Prairie Island Units 1 and 2
Transient Power Distribution
Methodology
NSPNAD-93003-A

SUBJECT: PRAIRIE ISLAND NUCLEAR GENERATING PLANT, UNIT NOS. 1 AND 2 -
DISTRIBUTION METHODOLOGY (TAC NOS. M86201 AND M86202)

SAFETY EVALUATION BY THE OFFICE OF NUCLEAR REACTOR REGULATION
RELATED TO TRANSIENT POWER DISTRIBUTION METHODOLOGY
NORTHERN STATES POWER COMPANY
PRAIRIE ISLAND NUCLEAR GENERATING PLANT, UNIT NOS. 1 AND 2
DOCKET NOS. 50-282 AND 50-306

FIGURE IX.A

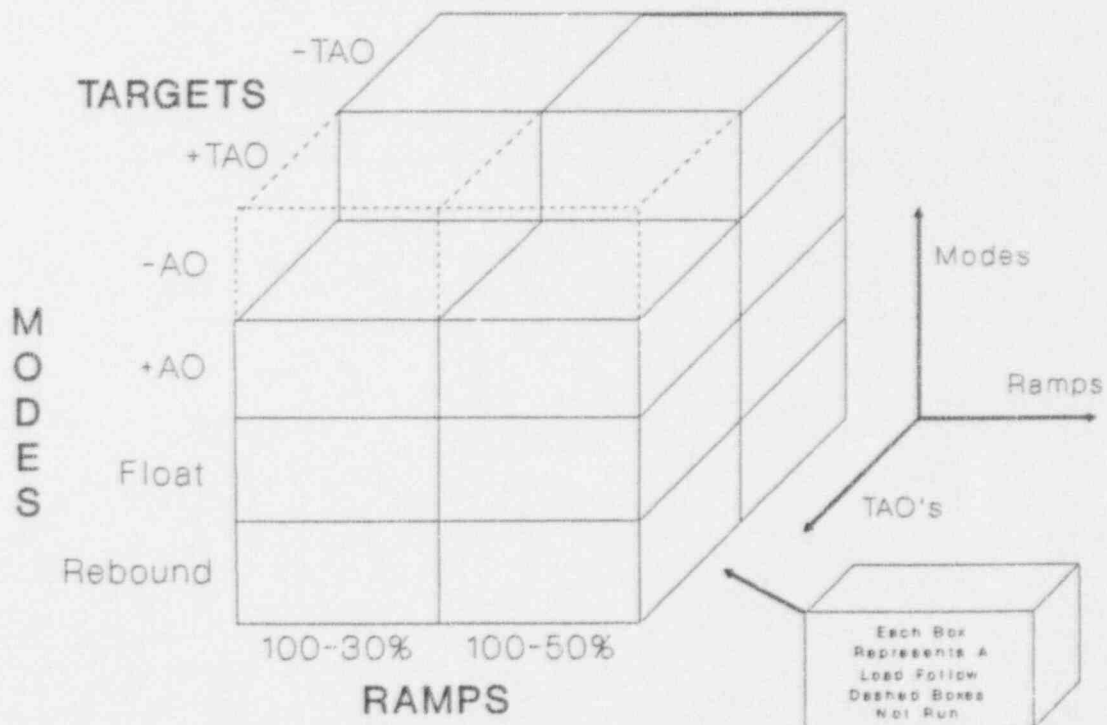
- (1) The cycle specific case list presented in Table IX.A and Figure IX.A must be used.
- (2) The cases run must represent allowable Prairie Island Technical Specification operating conditions.
- (3) The analyzed TAO values must bound the measured equilibrium axial offsets over the exposure range of interest.

Figure X.G

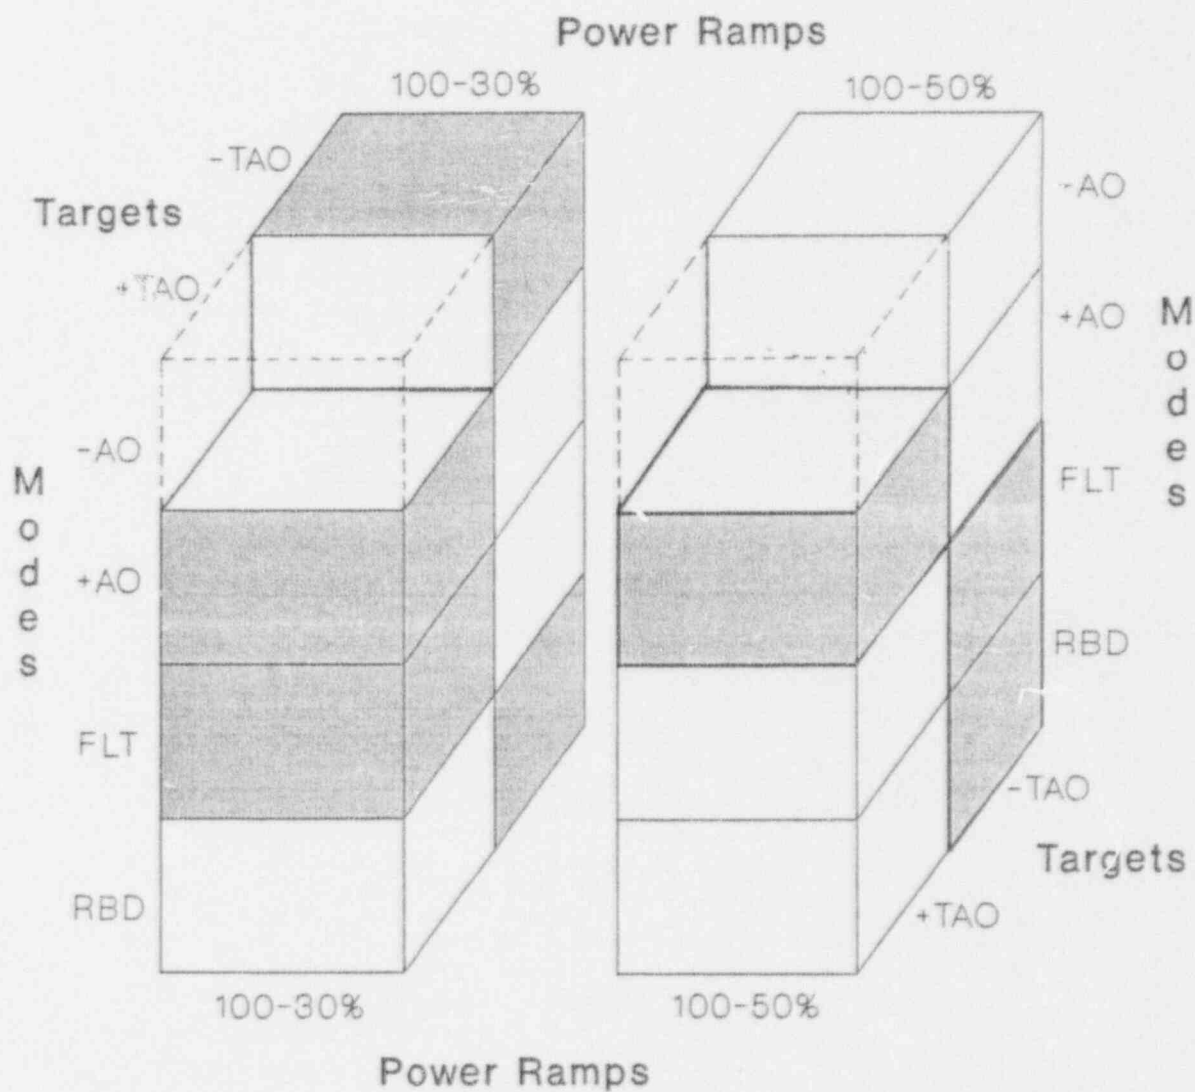
- (1) The generic curve must be generated from at least 3 cycles of data with no technical specification changes to power distribution control strategies having occurred since the generation of the generic curve.
- (2) The generic case list presented in Table X.A and Figure X.G represents the limiting cases necessary for qualification of the generic curve.
- (3) The analyzed TAO values must bound the measured equilibrium axial offsets over the exposure range of interest.
